E/ECE/324
E/ECE/TRANS/505 } Rev.1/Add.21/Rev.2/Amend.3

Addendum 21 – Regulation No. 22 annexed to the Agreement

Revision 2 – Amendment 3

UNIFORM PROVISIONS CONCERNING THE APPROVAL OF PROTECTIVE HELMETS AND OF THEIR VISORS FOR DRIVERS AND PASSENGERS OF MOTOR CYCLES AND MOPEDS

ARRANGEMENT OF APPROVAL MARK FOR A PROTECTIVE HELMET
WITHOUT OR WITH ONE OR MORE TYPES OF VISOR

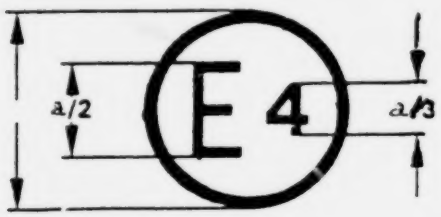
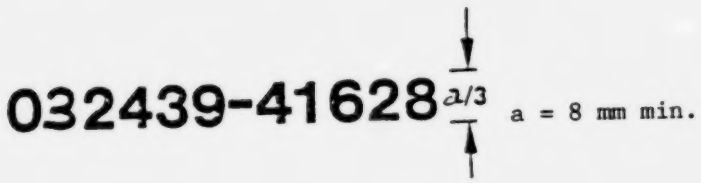
Annex 2 amend to read as follows:

The above approval mark affixed to a protective helmet shows that the helmet type concerned has been approved in the Netherlands (E4) under approval number 032439. The approval number shows that approval was granted in accordance with the requirements of the Regulation already incorporating the 03 series of amendments at the time of approval, and that its production serial number is 41628.

Note: The approval number and the production serial number shall be placed close to the circle and either above or below the letter "E" or to the left or right of that letter. The digits of the approval number and of the production serial number shall be on the same side of the letter "E" and face the same direction. The use of Roman numerals as approval numbers should be avoided so as to prevent any confusion with other symbols.

Figure 1: Sand spray equipment

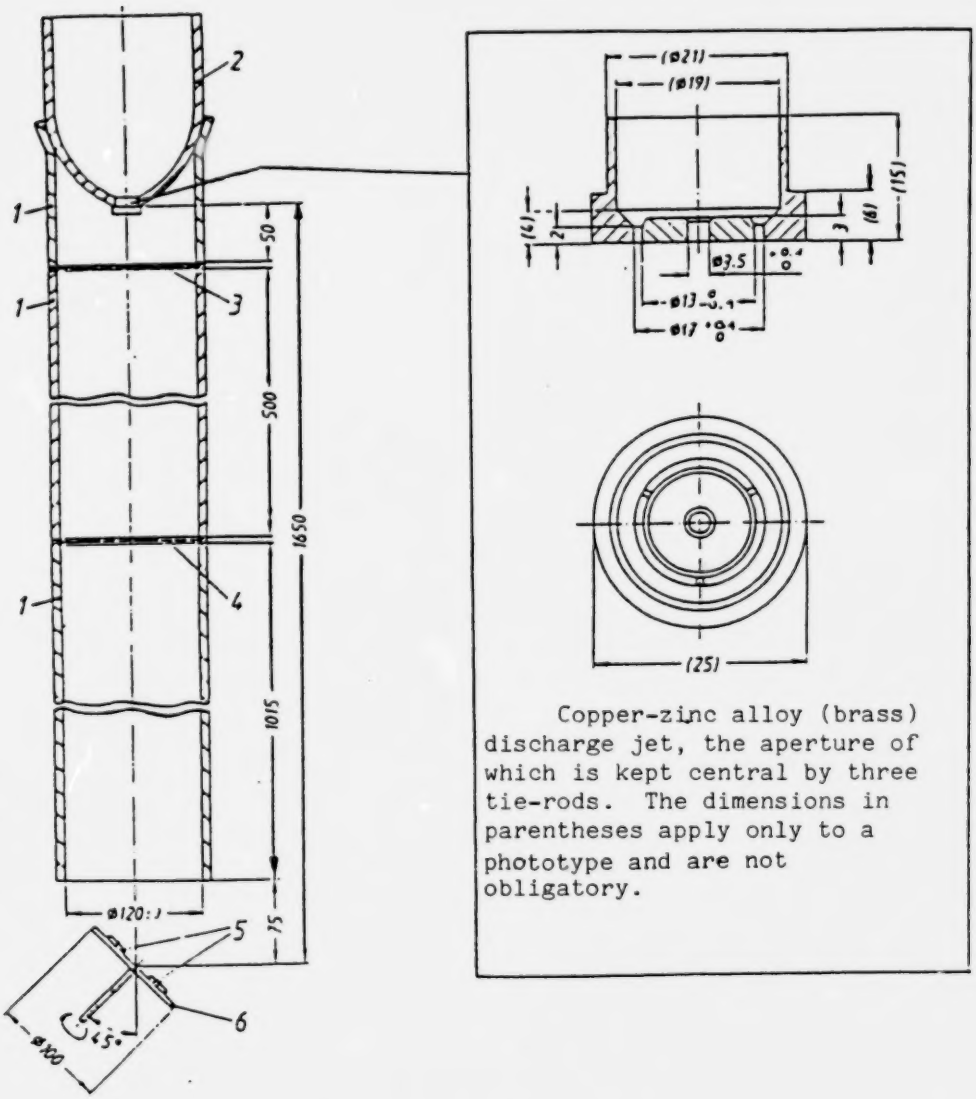
Add the following new annex 10:

The sand spray test equipment consists essentially of that illustrated in Figure 1. The gravity tube consists of three separate rigid polyvinylchloride tubes (PVC hard) of the same diameter, with two polyamide sieves mounted in between. The sieves should have a mesh size of 1.6 mm. The speed of the turntable shall be 250 ± 10 r.p.m.

Copper-zinc alloy (brass) discharge jet, the aperture of which is kept central by three tie-rods. The dimensions in parentheses apply only to a phototype and are not obligatory.

1. Parts of gravity tube
2. Container with discharge jet as figure 2, containing at least 3 kg sand
3. Upper sieve
4. Lower sieve
5. Test piece
6. Test piece holder (turnable)"

1.1. EQUIPMENT

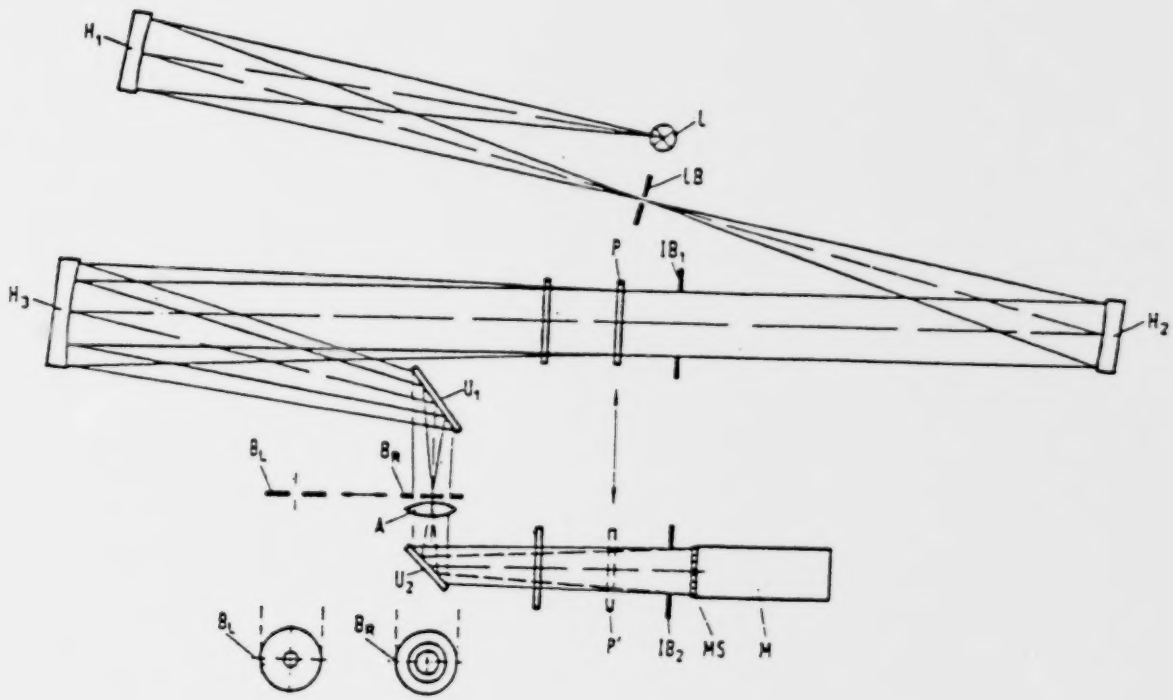
Add the following new annex 11

This assembly collects all the unscattered light originating from the visor up to an angle of 0.72 degree (using diaphragm B_L) and all scattered light between the angles 1.5 degrees and 2 degrees in relation to the optical axis using diaphragm B_R. The angular area is important in the case of night riding, where a range in the immediate proximity of headlights has to be observed. The following dimensions are an information for the possible realization:

L	High-pressure xenon lamp (for example XBO 75 W)
H_1	Spherical concave mirror: focal length 150 mm; diameter 40 mm
H_2	Spherical concave mirror: focal length 300 mm; diameter 40 mm
H_3	Spherical concave mirror: focal length 300 mm; diameter 70 mm
A	Achromatic lens: focal length 200 mm; diameter 30 mm
U_1, U_2	Flat mirrors
B_R	Annular diaphragm: diameter of outer circle 21.00 mm; diameter of inner circle 15.75 mm
B_L	Circular diaphragm: diameter of aperture 7.5 mm
M_L	Silicon detector corrected according to curve V (2) with diffusing screen MS
IB_1	Iris-diaphragm to adjust diameter of field of observation, diameter 40 mm
IB_2	Iris-diaphragm to eliminate edge effects from IB_1
LB	Circular diaphragm, diameter of aperture 1 mm
P, P'	Positions of visor.

Spherical mirror H_1 forms an image of light source L at diaphragm LB which is in the focal plane of H_2. The concave mirror H_3 forms an image of diaphragm LB in the plane of diaphragms B_L and B_R. The achromatic lens A is positioned immediately behind the diaphragm so that a reduced image of the test sample in position P appears on diffusing screen MS. The image of iris-diaphragm IB_1 is simultaneously formed on IB_2.
